FutureGen Industrial Alliance, Inc.  
73 Central Park Plaza East  
Jacksonville, IL 62650  
[www.FutureGenAlliance.org](http://www.FutureGenAlliance.org)

**Subject: Request for Additional Information #1 Regarding, FutureGen Applications for UIC Permit nos. IL-137-6A-0001, -0002, -0003 & -0004, dated October 31, 2013**

## **RAI# 10-31-2013\_009**

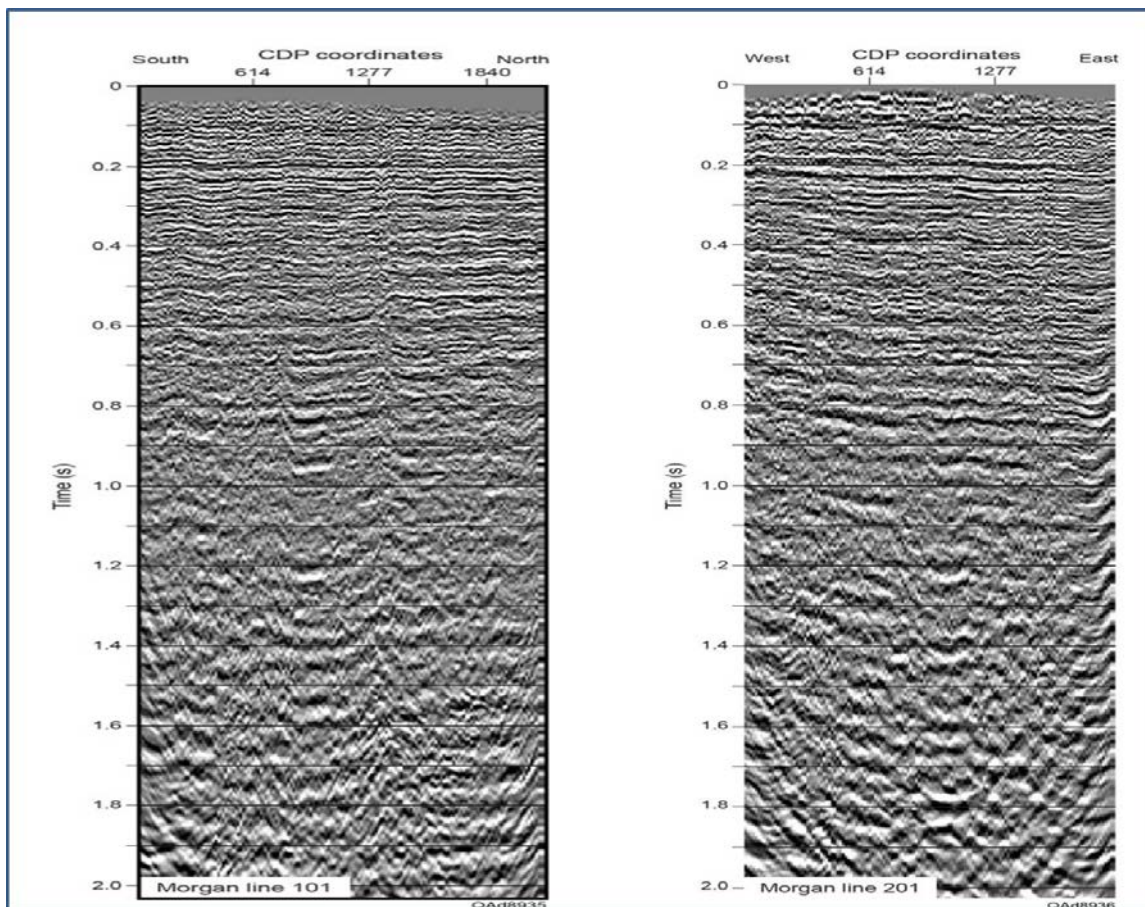
The original data exhibit vertical discontinuities with little to no offset, and a severe loss of frequency and resolution below a two-way time (TWT) depth of about 0.3 seconds (S), approximately coincident with the top of the Galena limestone at a depth of 1,400 feet. The original data were evaluated by Dr. Hardage<sup>1</sup>, who concluded that the discontinuities could be acquisition/processing artifacts or could be very small offset faults. In August, 2012, these lines were reprocessed by Exploration Development, Inc., and re-evaluated by Dr. Hardage<sup>2</sup>. Although the reprocessed data had less seismic noise, vertical discontinuities remained (Figure 2), especially at locations where the seismic lines crossed small streams.

A second interpretation of the Morgan County 2D lines was provided by Dr. John McBride (geophysicist from Brigham Young University, formerly ISGS), *"There are no large scale features in the Morgan County site data that cut into the shallow section, however it cannot be definitively determined that there are no faults in the Morgan County data. Some anomalies coincide with streams; others may be related to binning issues. Better static corrections may be required in order to determine if offsets in the shallow (0-400 ms) section are actual small faults or are just distortions due to unaccounted-for lateral velocity changes (e.g., associated with small stream valleys)."*<sup>3</sup>.

Discontinuities observed in the Morgan County 2D lines were not resolved by reprocessing the lines in 2012; two independent seismic specialists conclude that the remaining vertical discontinuities have a high probability of being artifacts due to acquisition and processing, specifically related to incomplete removal of surface seismic noise caused by offsets in acquisition lines ("crooked lines") and streams, by the choice of filters used during processing, and other processing parameters.

**Figure 5: Offset VSP Source Stations. The lateral lengths of good-quality VSP images (Table 1) are indicated by the lengths of the lines in the spoke wheel pattern centered on the FGA-1 well. Distance from the stratigraphic well to Station 15 is approximately 4000 ft.**

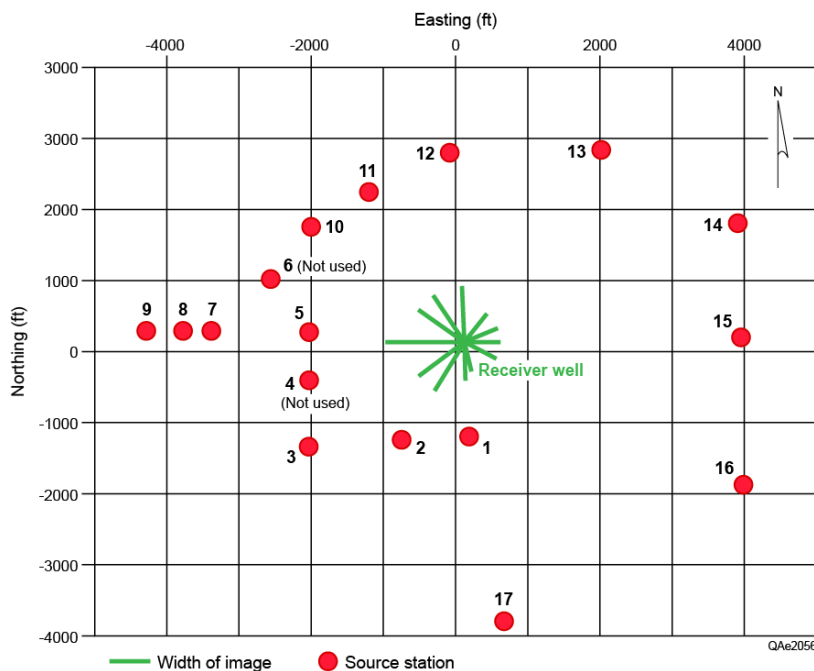
The resulting P-P and P-SV data were interpreted by Dr. Bob Hardage, who determined that no discontinuities of the type observed in 2D Line L101 or L201 are present in the VSP images<sup>5</sup> and that there is no evidence of faults in any of the images<sup>6</sup>. Dr. Hardage pointed out that the areas imaged by the short 2D lines generated by the VSP surveys still represent a small part of the site.

A zero offset VSP and 15 offset VSP's were acquired in March 2013 to better determine if faults or fracture zones are present at the site. The VSP images are good quality, and no vertical discontinuities were observed in any of the offsets. Interpretation by Dr. Bob Hardage<sup>7</sup> of the data indicates there is no evidence of faulting within the VSP image space.

**Figures 4.4, 4.5, 6.1, and 6.2**

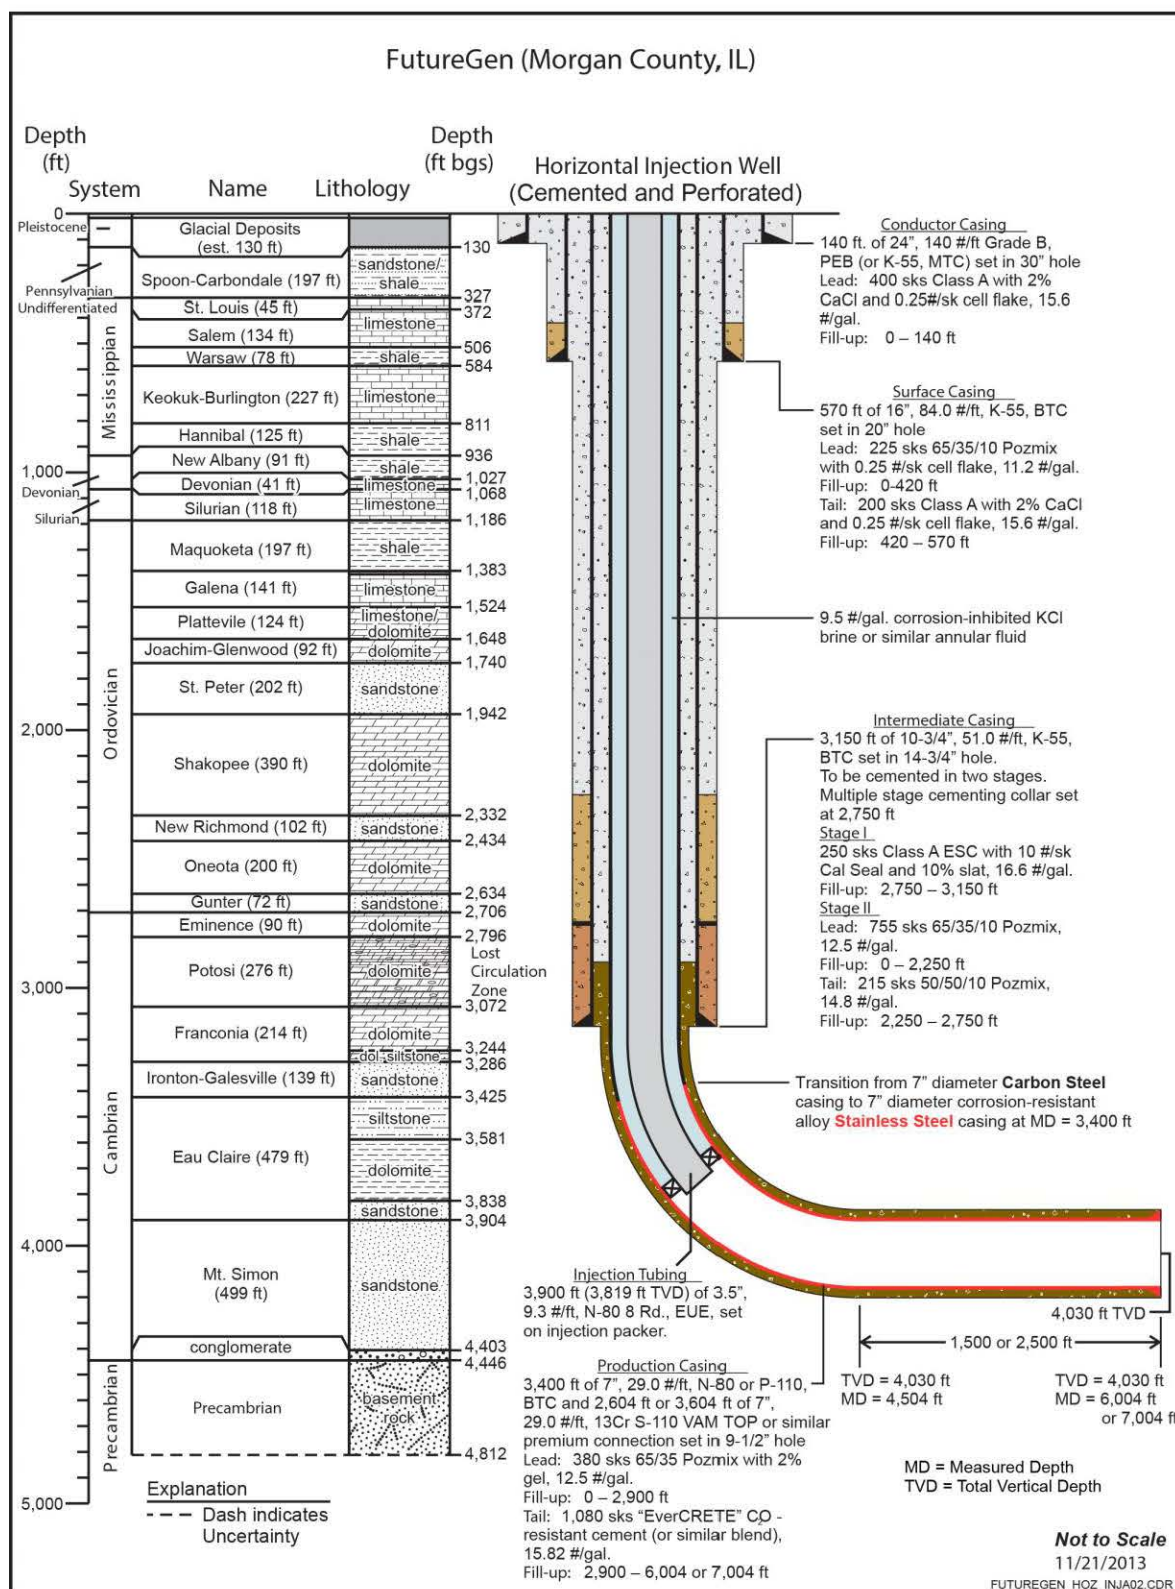
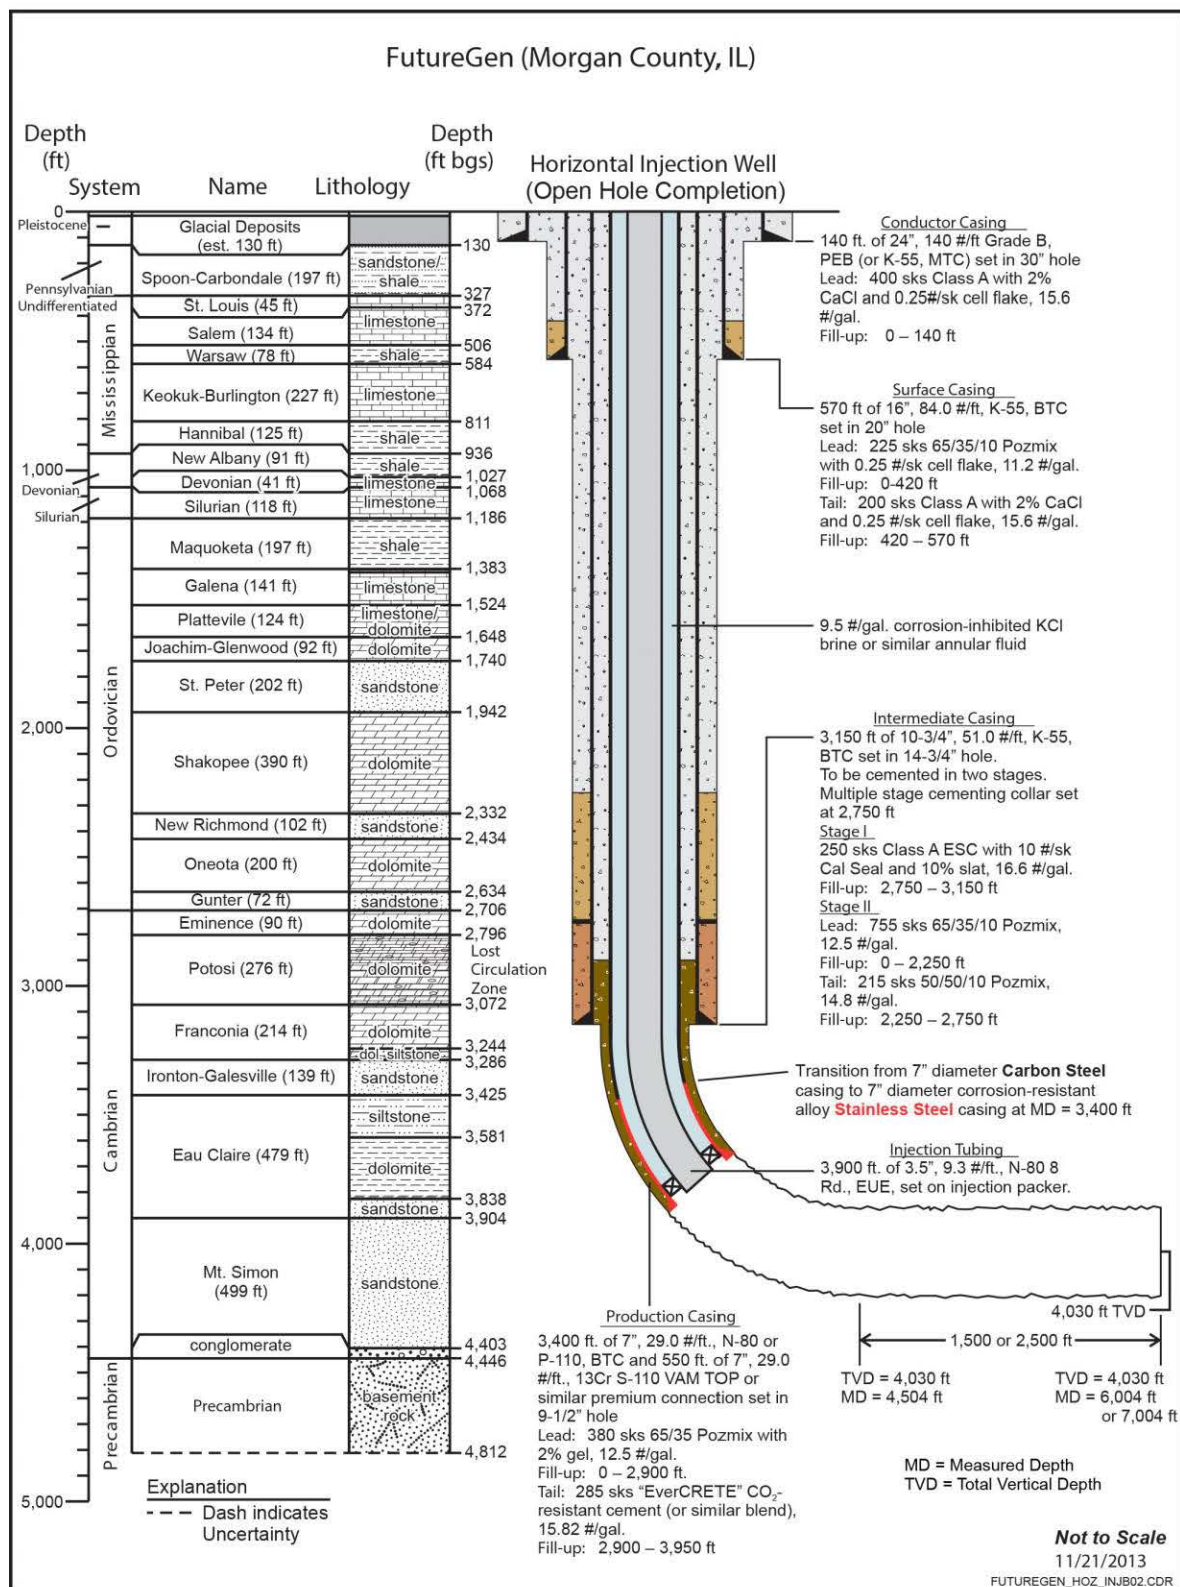
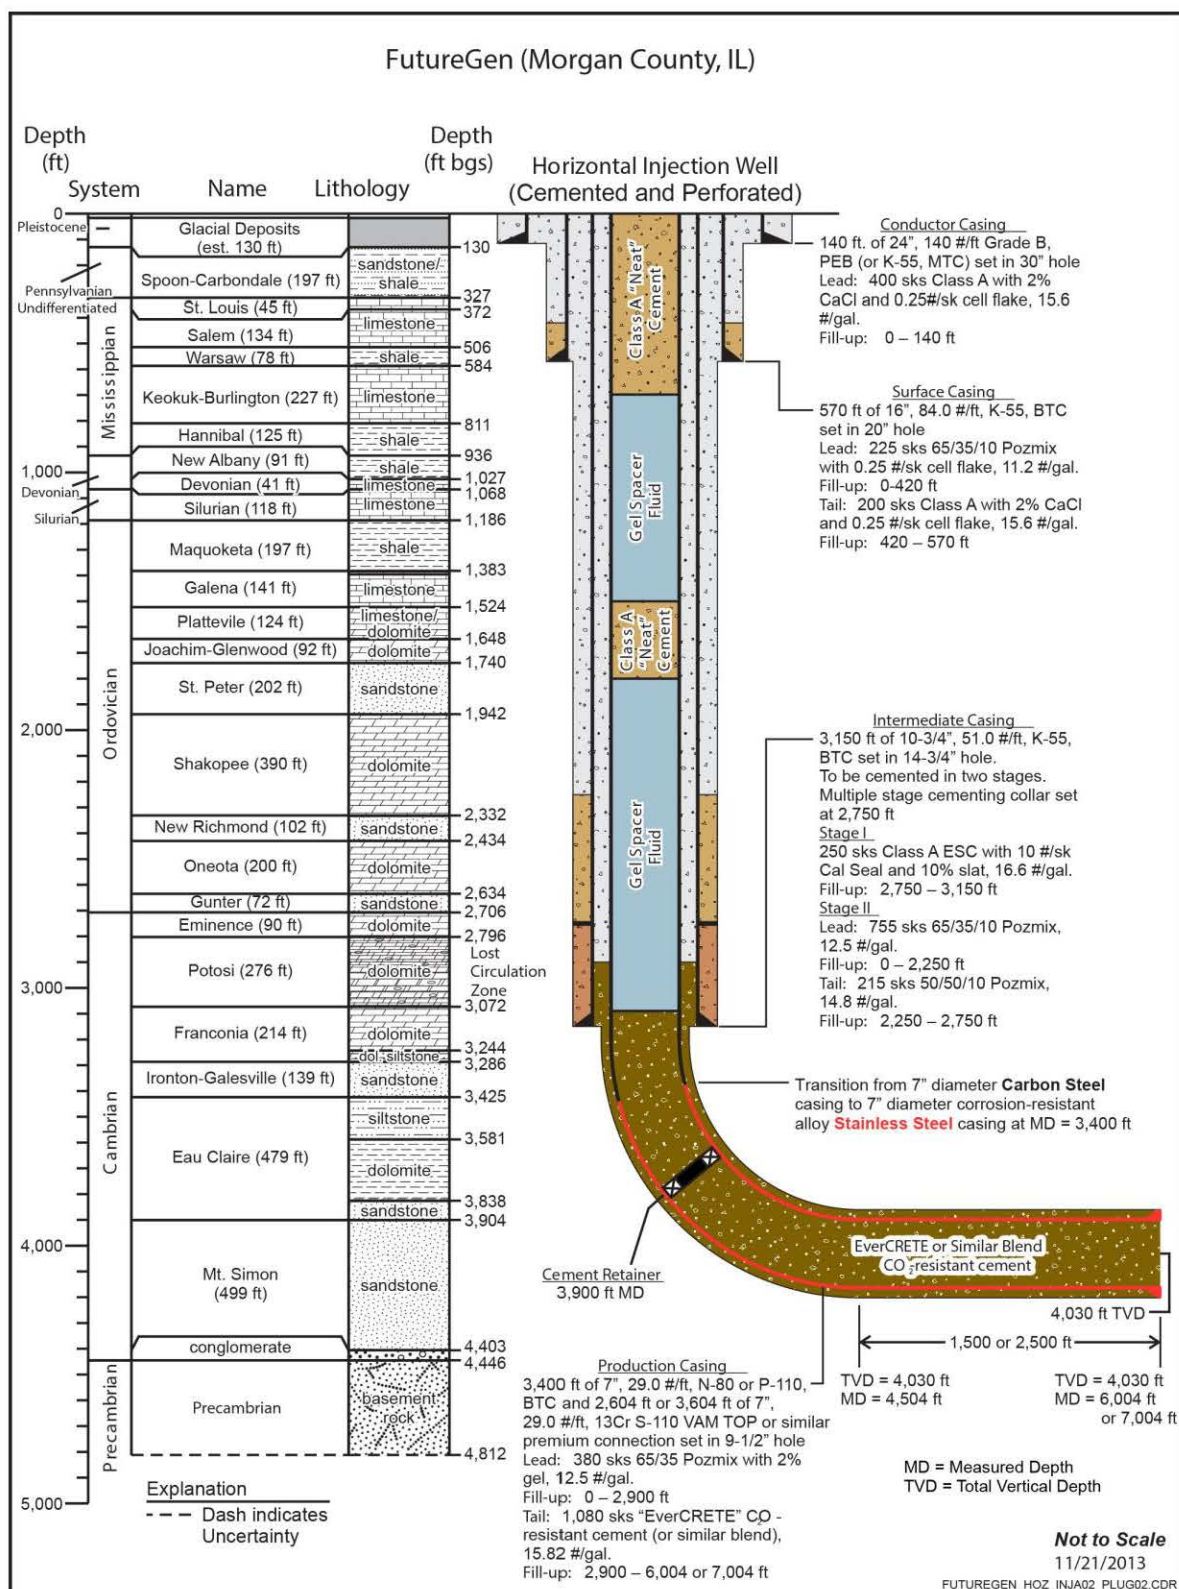
10-31-2013_009	Casing & Retainer in Figure 6.2	6.5	6		<p>In <b>Figure 6.2</b>, the 7" casing is set at 3400 feet, however a cement retainer will be at 3900 feet, which is below the cased hole.</p> <p><b>EPA: Please correct.</b></p>	The carbon-steel casing will be run to a depth of 3,400 ft and stainless steel casing will be run from 3,400 ft to 3,950 ft. For clarity, an updated version of Figure 6.2 is attached in <a href="#">Appendix D</a> . For consistency, Figures 4.4, 4.5, and 6.1 have also been updated and are provided in <a href="#">Appendix D</a> .
